# **Upgrade Information of MPE720 Version 5.42**

Items added and features improved from MPE720 version 5.41 to version 5.42 are as follows.

## No.1 Support to 263IF-01 module

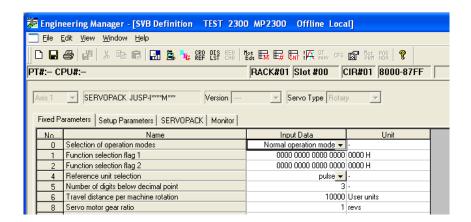
It supported to the 263IF-01 module that was the new option module.

The 263IF-01 module(EtherNet/IP) has the function of EtherNet/IP that mounts standard (EN50170, IEC 61158)CIP (Common Industrial Protocol) where results exist in DeviceNet in the TCP/IP protocol of standard Ethernet. The EtherNet/IP function can handle the I/O message and the Explicit message.

#### No.3 Addition of "Absolute Encoder Reset Completed".

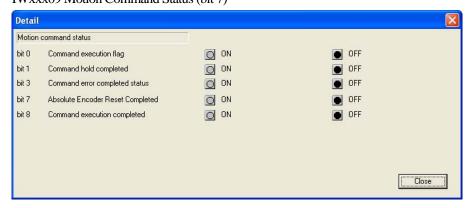
"Absolute Encoder Reset Completed" was added to the monitor parameter of the SVB module.

IWxxx09 Motion Command Status (bit 7)

#### No.4 SVA Fixed Parameter Addition.

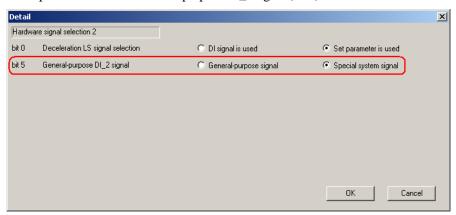
In SVA of the MP2000 series, the mode that interchangeable to CP9200 SVA operated about the operation of general-purpose DO\_2 it was added.

Fixed parameter No.21 General-purpose DI\_2 signal (bit 5)

#### **No.6 SVB Monitor Parameter Addition**

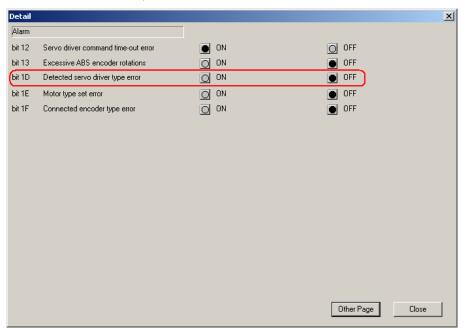
"Detected servo driver type error" was added to bit1D of motion monitor parameter 0x04 of SVB.

When the SERVOPACK allocated by the link assignment of the SERVOPACK and SVB actually connected with the motion module is different, bit1D is turned on.

## No.8 The Unit Display of the Monitor Parameter was Corrected.

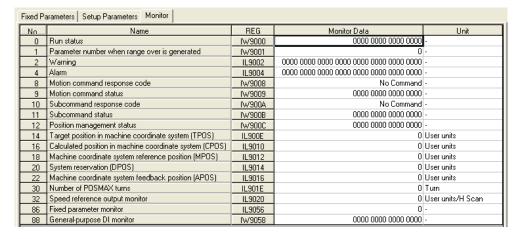
The unit display of the monitor parameter No.32 (Speed reference output monitor) of the PO module was corrected as follows.

The unit display is changed from "0.01%" to "User units/H Scan".
